**ADDENDUM NO. 1**

**PROJECT NAME:** City Campus Utility Plant North Cooling Tower Replacement General Installation Contract Package

**UNL PROJECT NUMBER:** C028P241  
**BID INVITATION NUMBER:** 2247-13-7200

**CONSULTANT:** Lutz, Daily & Brain, LLC  
6400 Glenwood, Suite 200  
Overland Park, KS 66202

DESIGNER: LUTZ, DAILY & BRAUN, LLC, DRAWN BY: WAH, CHECKED BY: BSS, APPROVED BY: BSS

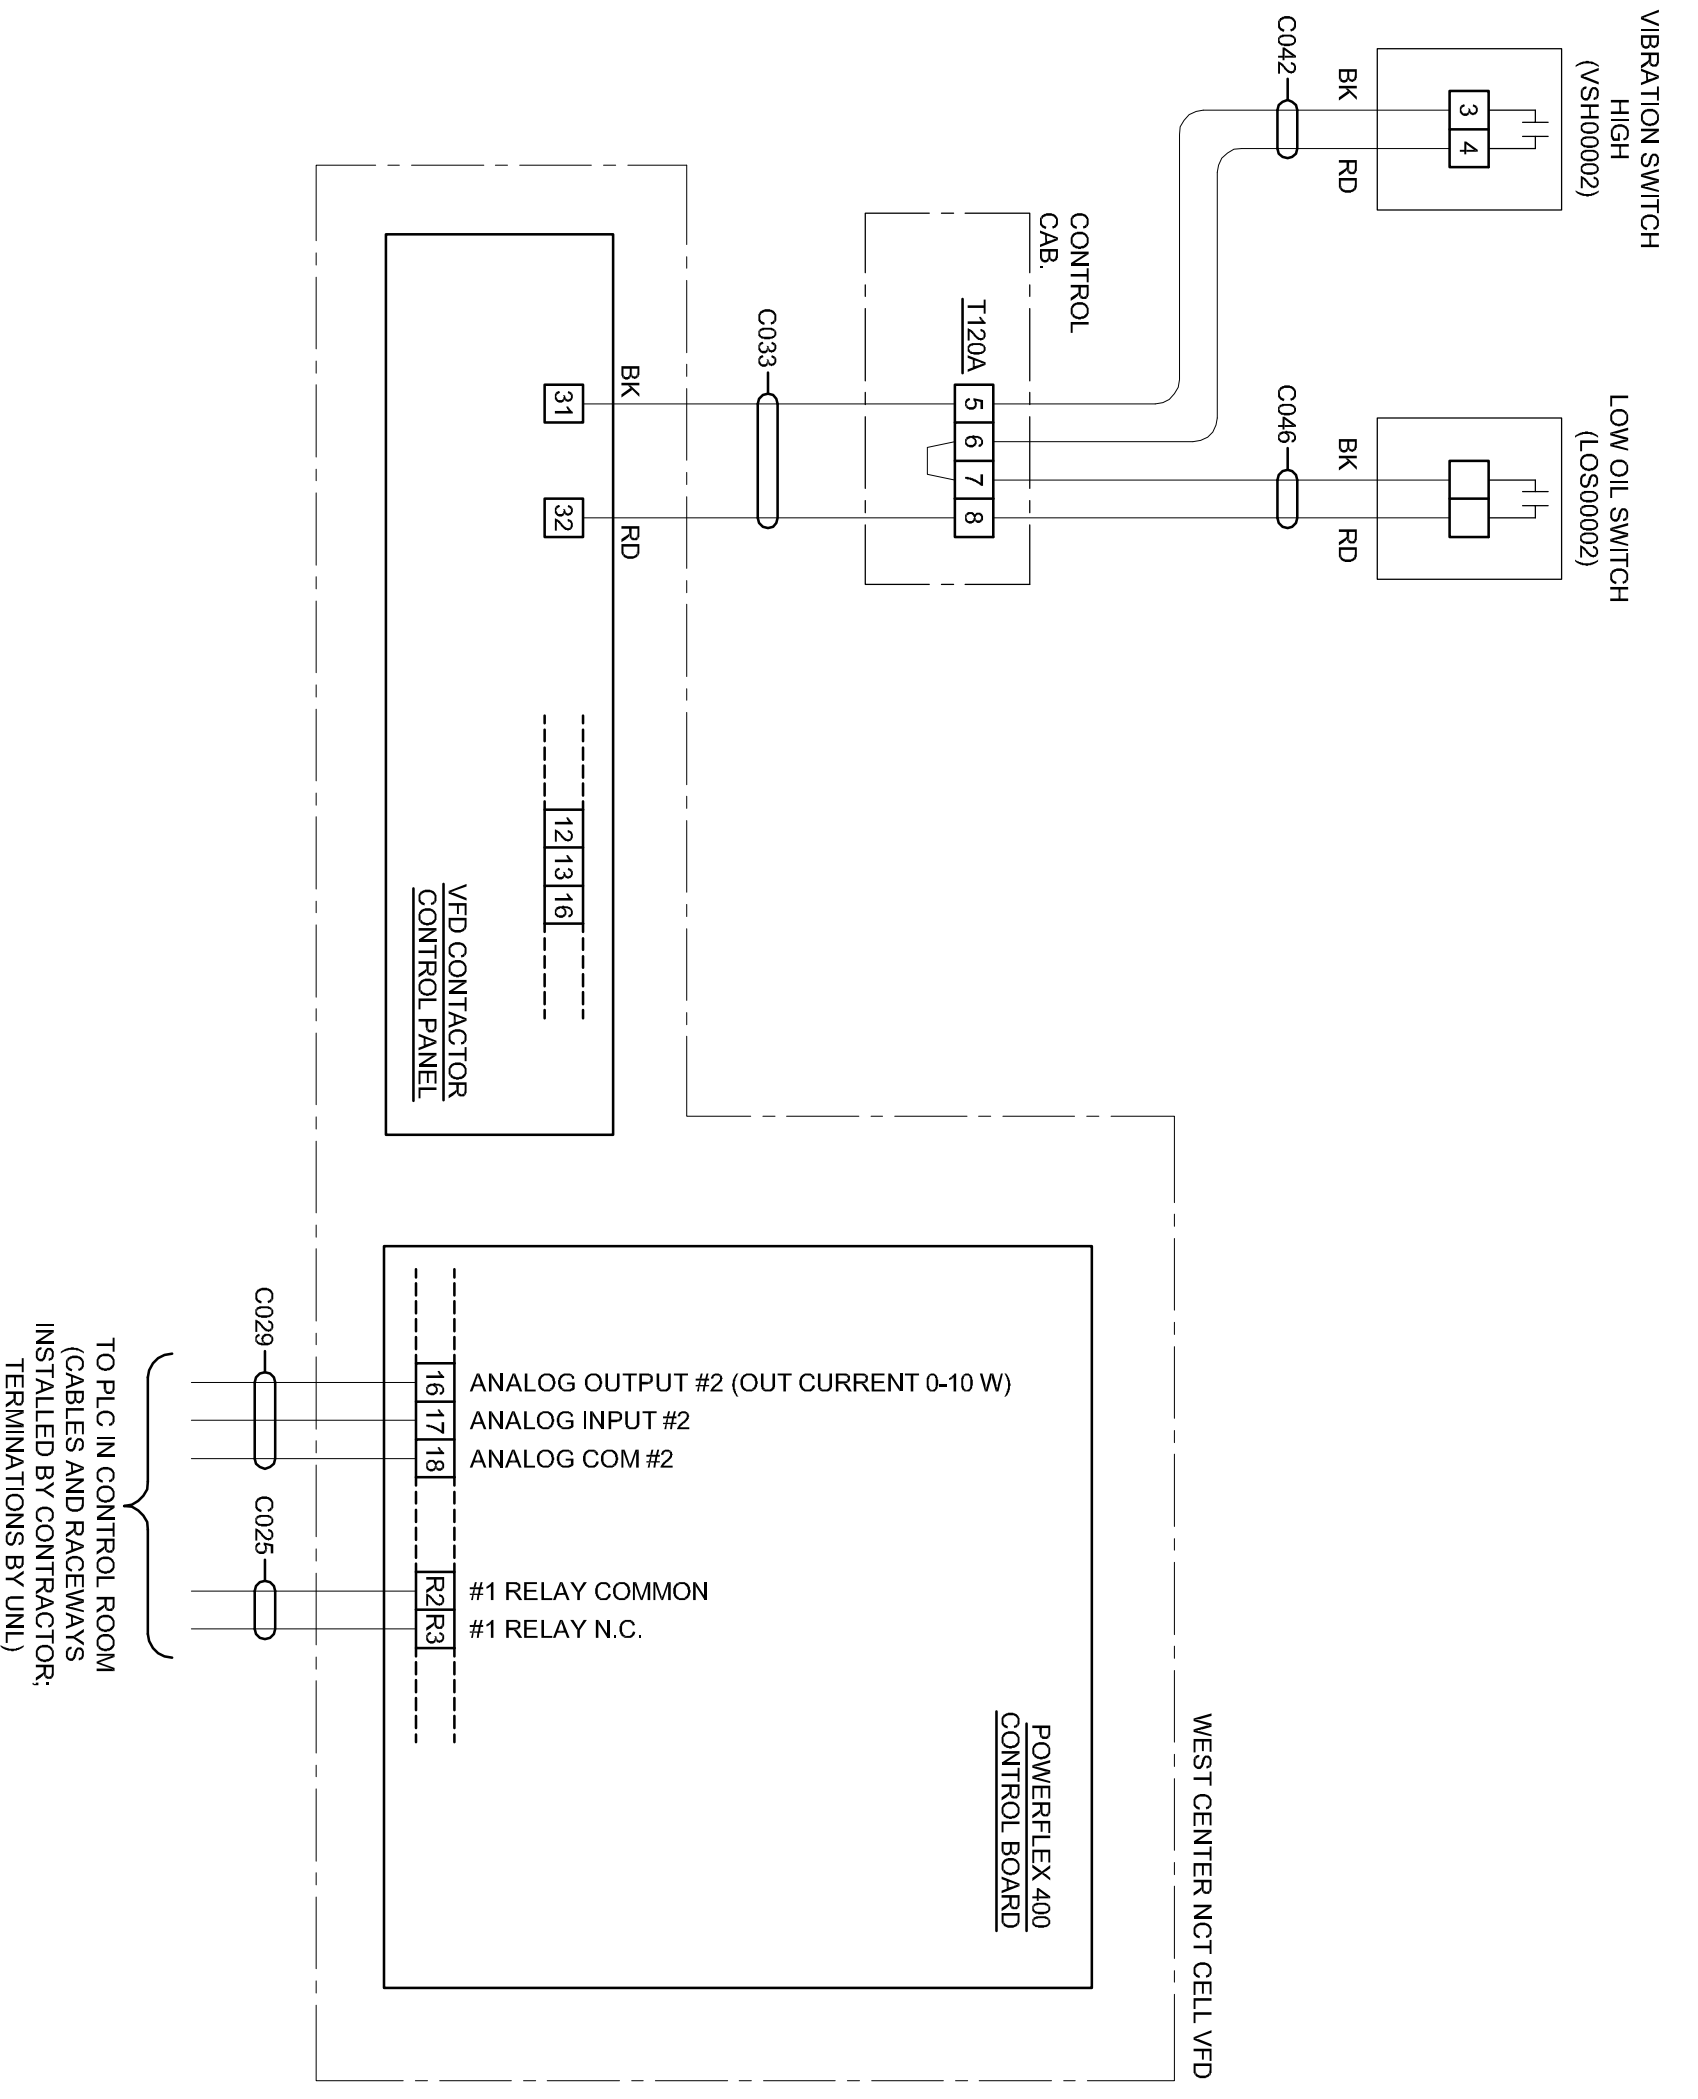
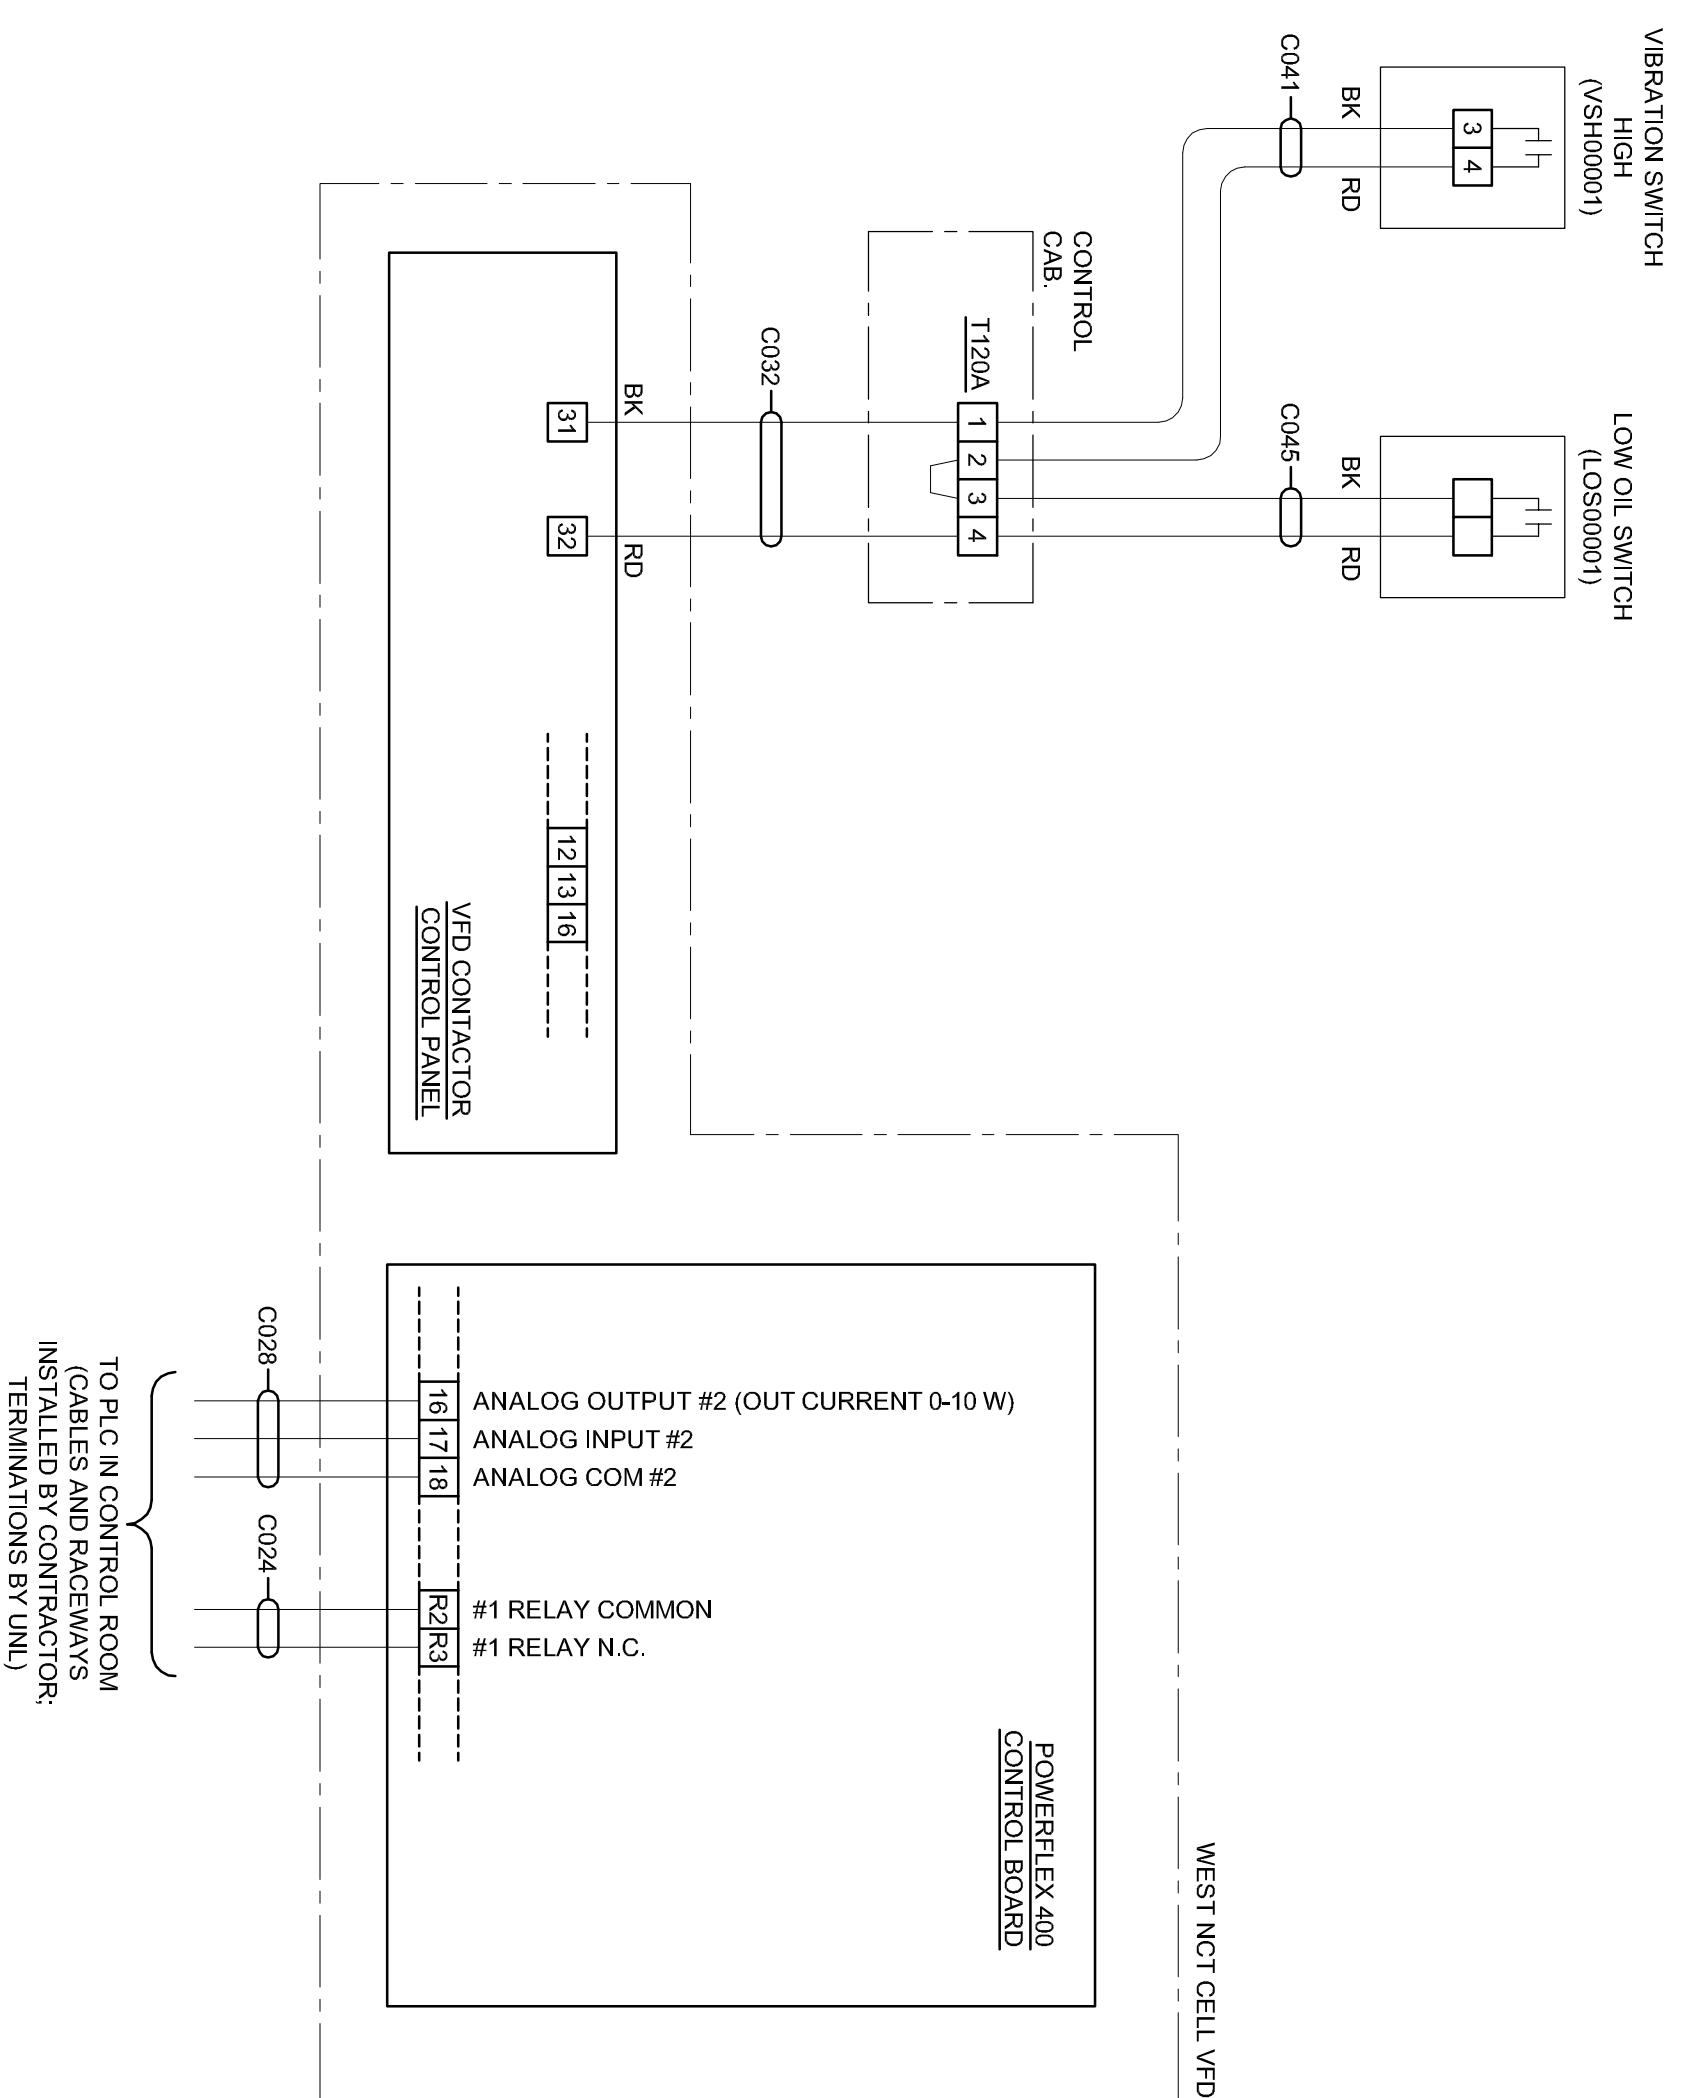
- 13.1 Drawings 40213-CCUP-NCT-E2, E3 & E4: 480V Hoffman enclosure removed from plan views.
- 13.2 Drawing 40213-CCUP-NCT-E6:
  - Circuit P005 increases in length from 80' to 155'.

- Circuit P006 increases in length from 160' to 235'.
  - Circuit P007 increases in length from 80' to 155'.
  - Circuit P008 increases in length from 105' to 180'.

- Circuit P009 increases in length from 130' to 205'.
  - Circuit P010 increases in length from 160' to 235'.
  - Circuit P011 decreases in length from 150' to 75'.

- Circuits P005-P010 "From" designation shall read "New 480V panel in basement" instead of "New j-box".
  - Circuit P011 "To" designation shall read "New 480V Panel in basement" instead of "New junction box".

- Raceway R045 "From" designation shall read "New 480V panel in basement" instead of "Duct Bank in CCUP basement".
  - Raceway R068 added to Raceway list and goes from new 480V panel to duct bank.

Raceways R005-R010 "From" designation shall read "new j-box at NCT" instead of "480V box".

Raceway R054 from new junction box to Hoffman box is deleted.

DRAWING NUMBER  
**40213-CCUP-NCT-E8**  
SHEET NUMBER  
**14**

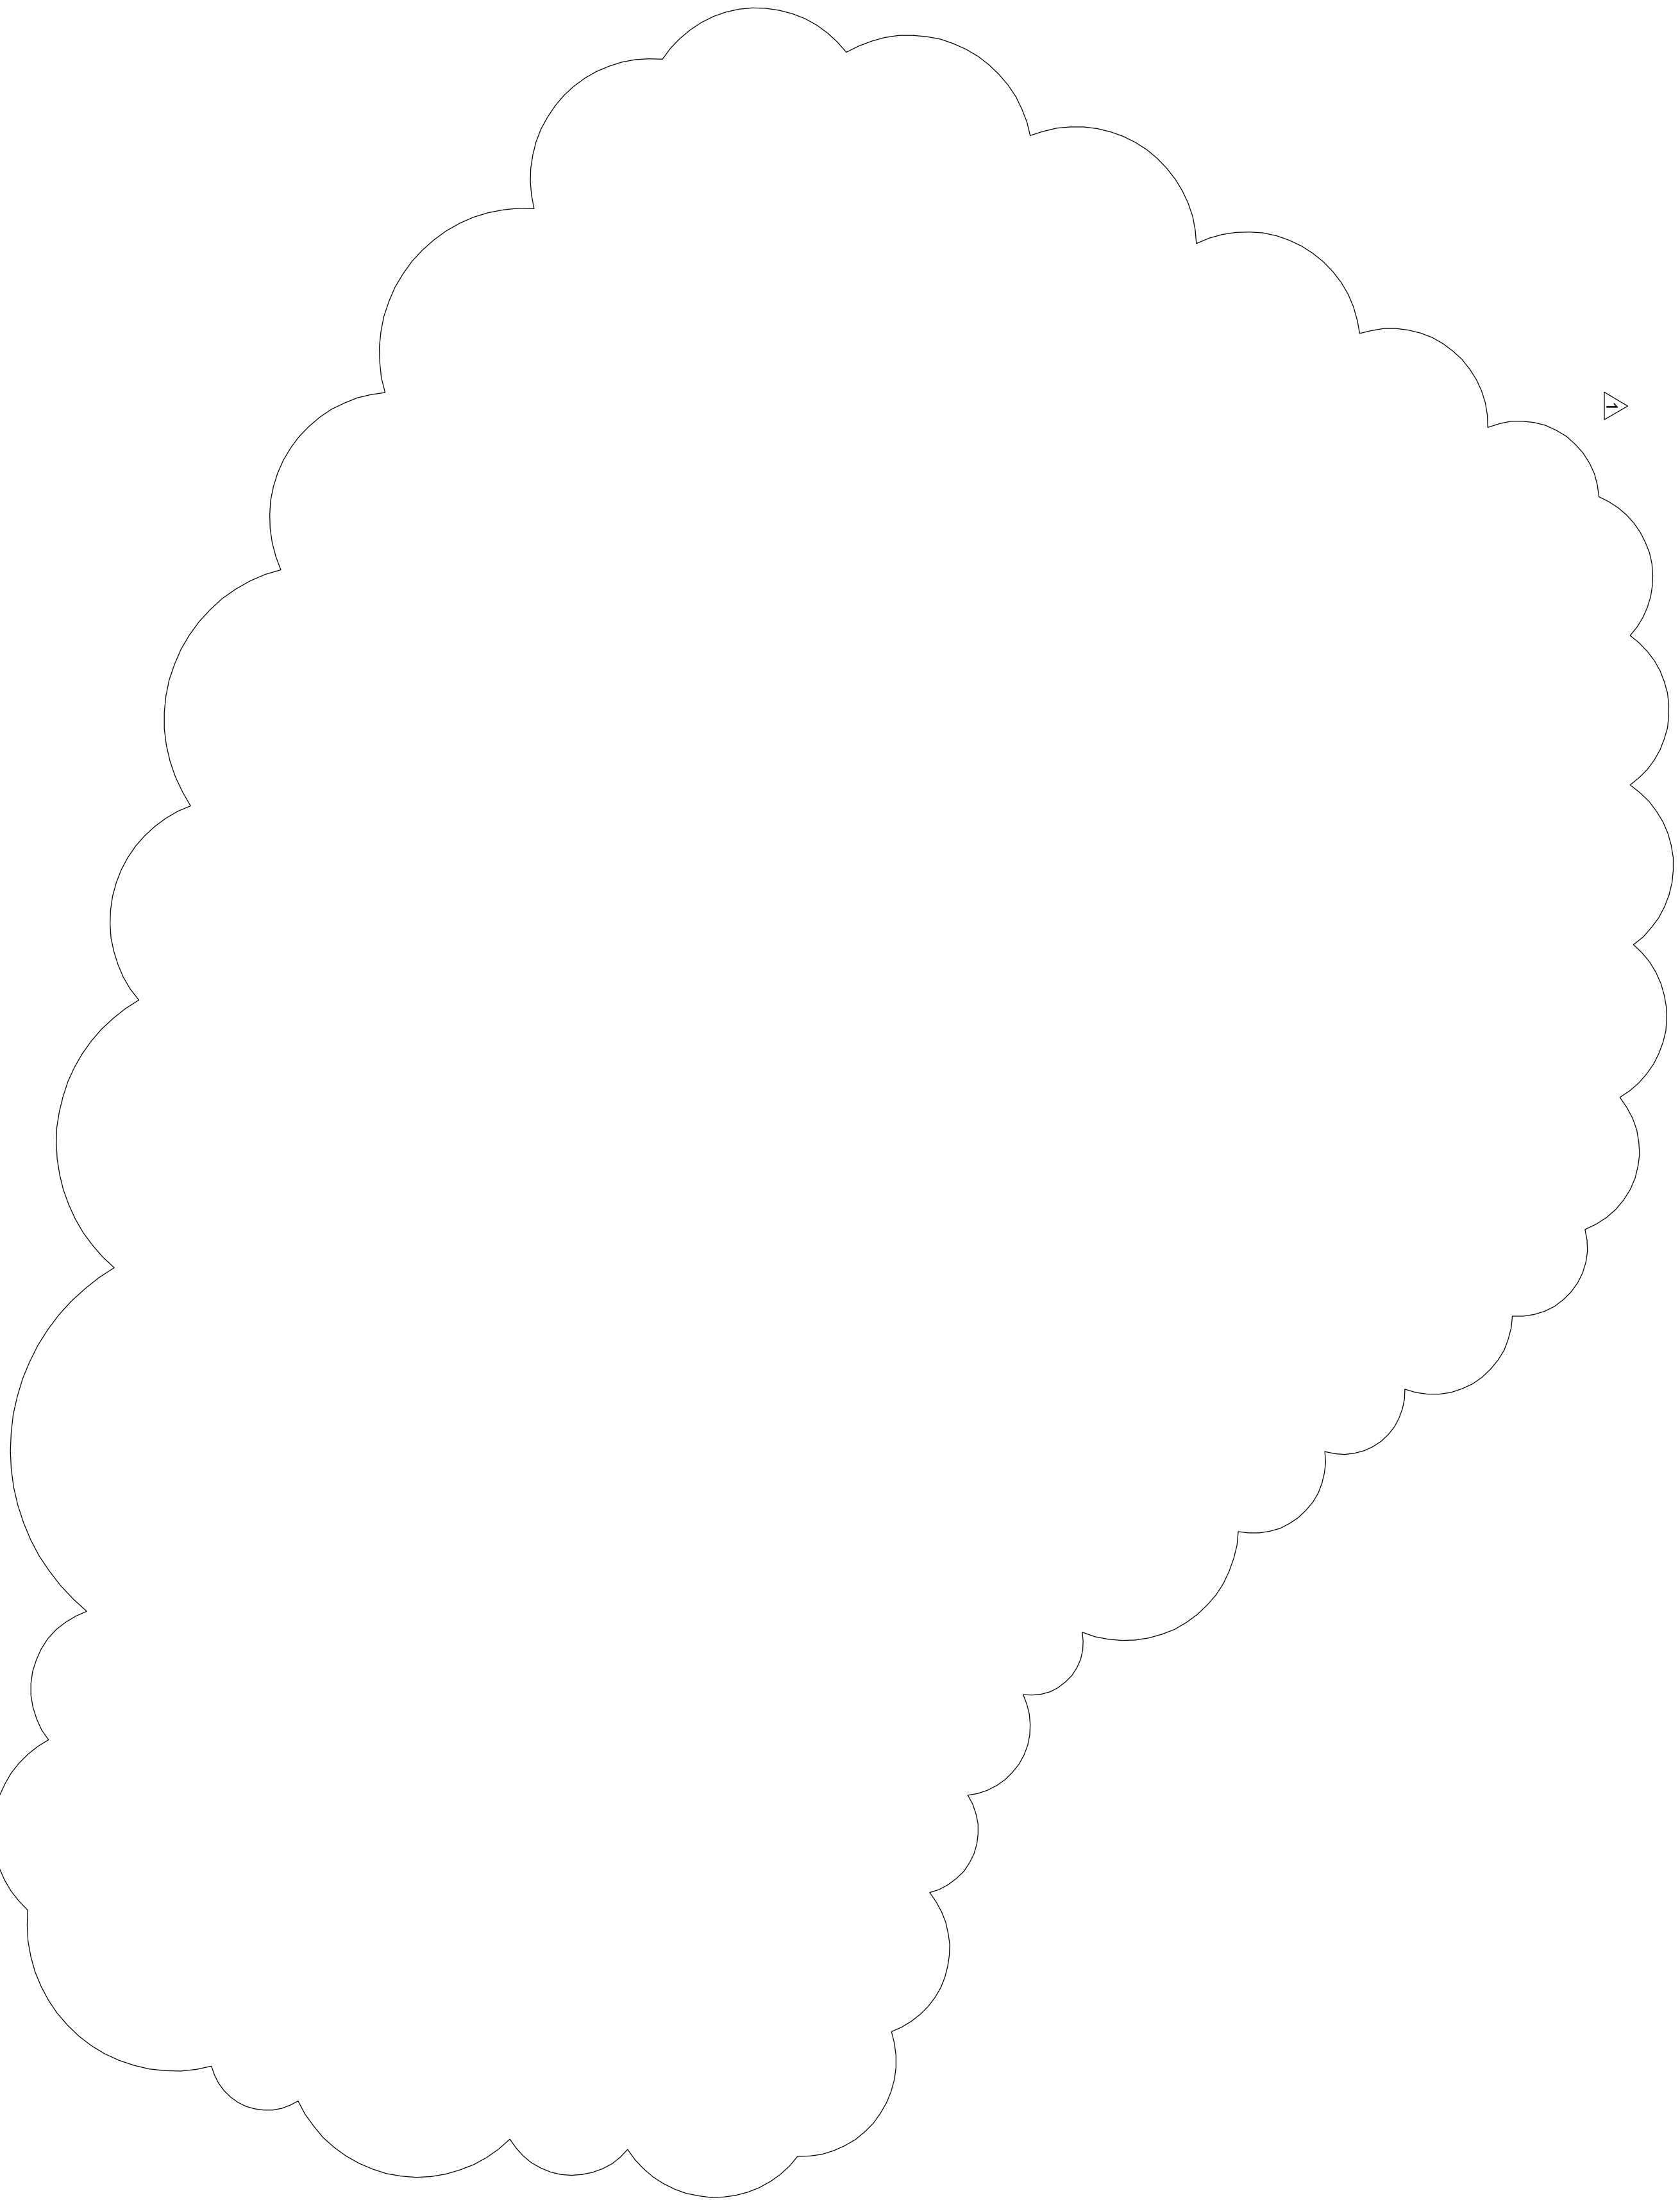
- 13.3 Drawing 40213-CCUP-NCT-E8: Detail of 480V supply enclosure is removed.
- 13.4 Drawing 40213-CCUP-NCT-E10: Add 480V panel onto basement plan view.
- 13.5 Section 26 70 00 Part 2.01 Paragraph B shall read: "Indoor 480V panel with 100A main - Square D Catalog No. HCN2774-1MN with box and surface mount 4-piece trim with door and six three-pole 15A breakers."
